| Subject: WATER LEAK BETWEEN DOORS AT B-PILLAR | Service Alert No.: SA-068/23 |
| | Last Issued : 10/19/2023 |

2019-2024 Mazda3 (Japan and Mexico Built)

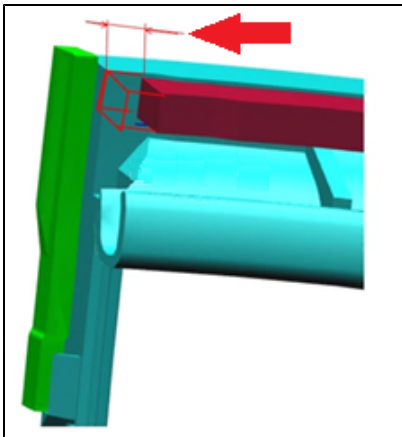
Some vehicles may have a water leak and/or a technician may find water inside the cabin or within a component. The source of the leak may be from between the doors at the B-pillar. To correct this concern, there was a mass production change (MPC) on January 14, 2021 to reduce the gap (as seen in the image below).

3. Was the vehicle produced before January 14, 2021?

YES - Replace both front and rear door seals and retest for a leak.
